Accessibility Survey

City of Downey Deming Avenue - Fontana Street to Cul-De-Sac

Date of Inspection
8/8/2017

Prepared By
Disability Access Consultants
(800) 743-7067

Change in Level North of Fontana Street @ 33.929674274630, -118.129396140575

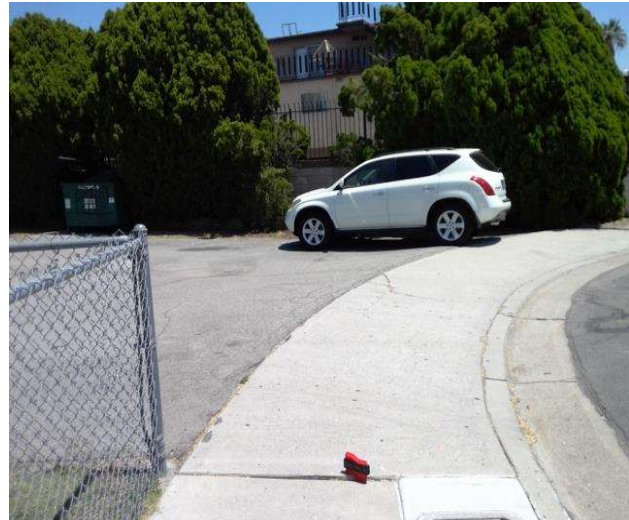
There is a change in elevation greater than recommended value.

On-Site Finding 0.75 inches

Ensure that the change in elevation is within the recommended value.

Recommendation Up to 0.25 inches

Change In Level North Of Castana Avenue @ 33.908855597807, -118.144142925739

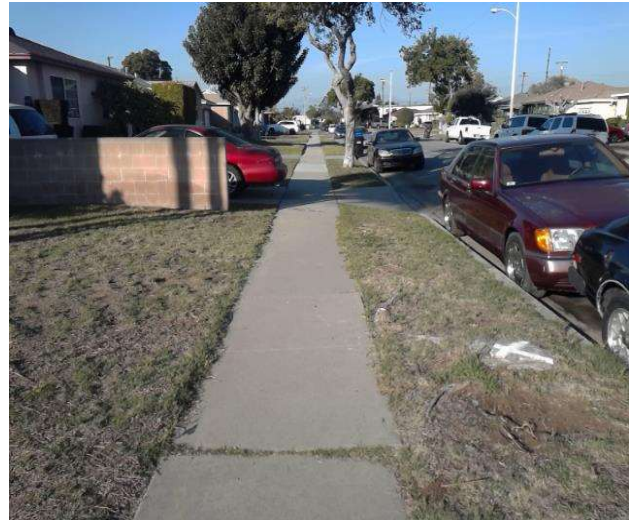
There is a change in elevation greater than recommended value.

On-Site Finding 1.00 inches

Ensure that the change in elevation is within the recommended value.

Recommendation Up to 0.25 inches

Tree North Of Lakewood Boulevard @ 33.908276826693, -118.144102692604

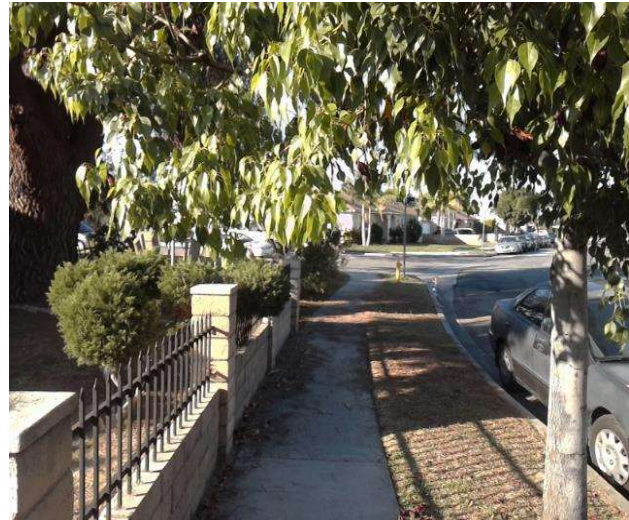
Overhead obstruction height is not compliant.

On-Site Finding 66.00 inches

Provide a compliant vertical clearance height.

Recommendation At least 80.00 inches

Driveway South Of End @ 33.904355548894, -118.144810795784

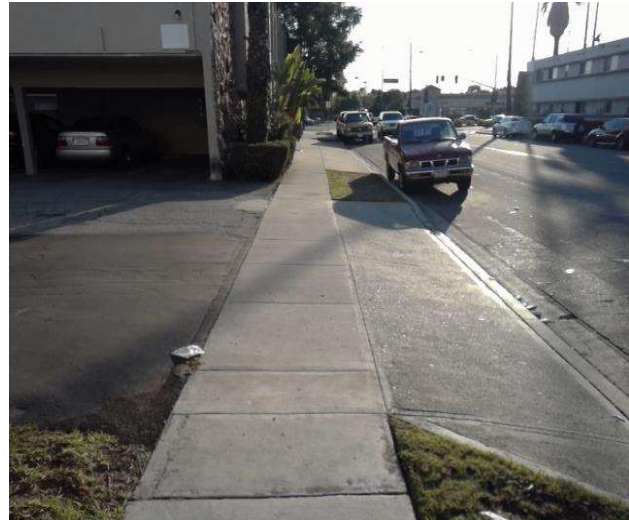
There are no detectable warnings where the pedestrian route crosses vehicular traffic.

On-Site Finding Not Found

Provide detectable warnings.
